INFORMAL DOCUMENT N°7

41st GRPE session

**Draft amendments to UN/ECE Regulation 67-01 series
with a view to update the requirements on the LPG vehicle connectors**

Figure 1: Bajonet connector configuration

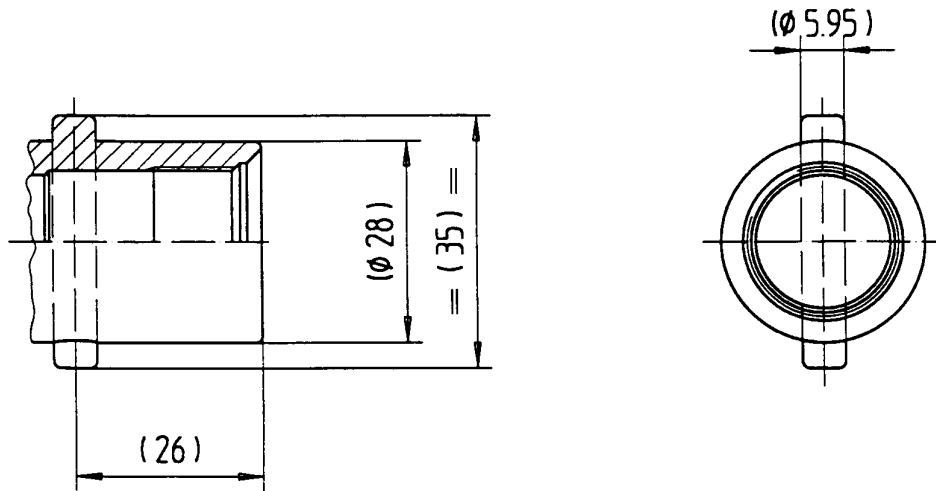
Note: If during the implementation period of the Euro connector, the connector body is replaced by a connector body of one of the currently existing types (see the drawings in the Annex 9 - paragraph 9), this connector body does not require a non-return valve.

6.15.14.8.1 Examples and critical dimensions of current vehicle connectors attachment points and sealing area configurations are shown in Annex 9 - paragraph 9.

Figure 4 Light vehicle Euro connector configuration

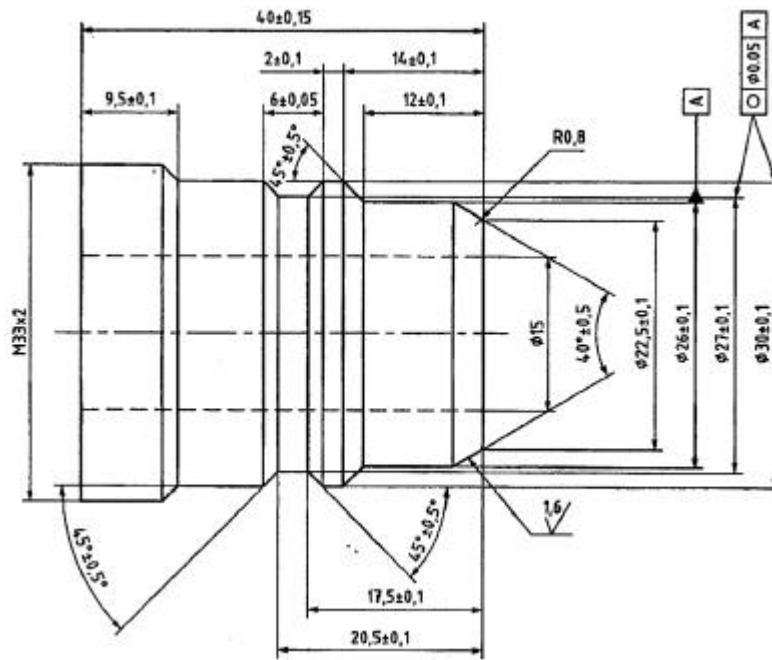
6.15.14.6 Specific provisions for the light vehicle Euro connector:

- The dead volume between the front sealing surface and the front of the non-return valve shall not exceed 0,1 cm³;
- The flow through the connector at a pressure difference of 30 kPa shall be at least 60 L/min, if tested with water.

6.15.14.8.2 Examples and critical dimensions of the light vehicle and heavy duty vehicle Euro connectors are given in Annex 9 - paragraph 10.

10.1 Critical dimensions of the light vehicle Euro connector

Figure 5 Installation of the light vehicle Euro connector

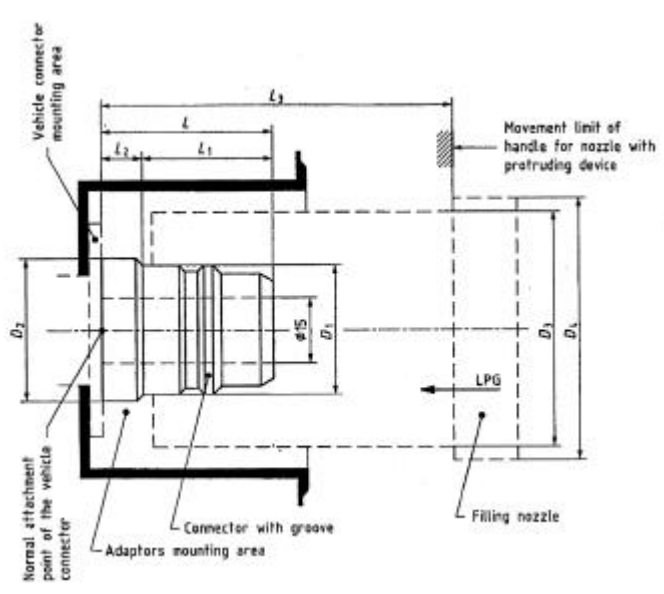
6.15.14.5.1 If the vehicle connector is composed of two parts, in order to facilitate the implementation of the light vehicle Euro connector on the market, it shall:

- be split in a valve body and a connector body, joined by thread M21,8 x 1,4G'' ; the male thread shall be at the connector body side;
- be provided with at least 1 soft seated non-return valve in the valve body and 1 soft seated non-return valve in the light vehicle connector body;

Figure 6 Critical dimensions of the heavy duty vehicle Euro connector

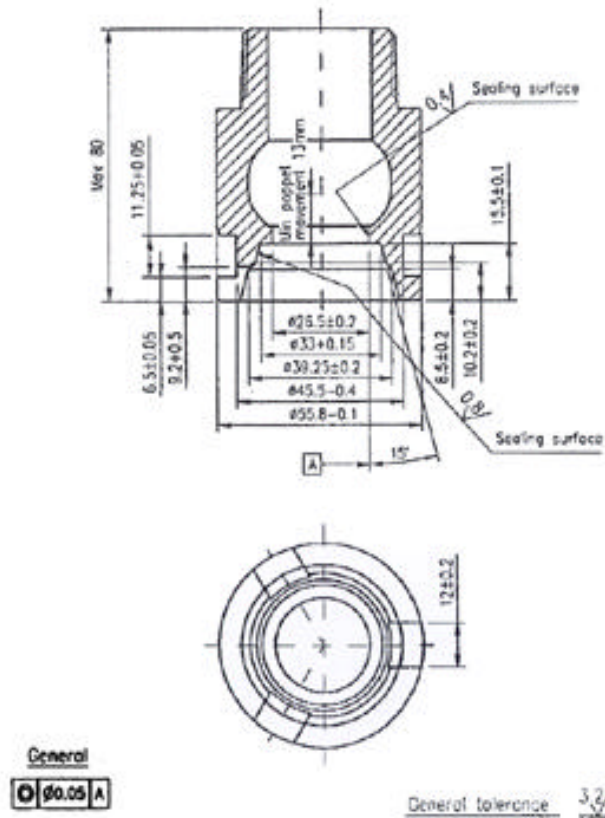
6.15.14.7 Specific requirements for the heavy-duty vehicle Euro connector:

- The dead volume between the front sealing surface and the front of the non-return valve shall not exceed 0,5 cm³;
- The flow through the connector, with the non-return valve mechanically opened, at a pressure difference of 50 kPa shall be at least 200 L/min, when tested with water.

Critical dimensions of the heavy duty vehicle Euro connector
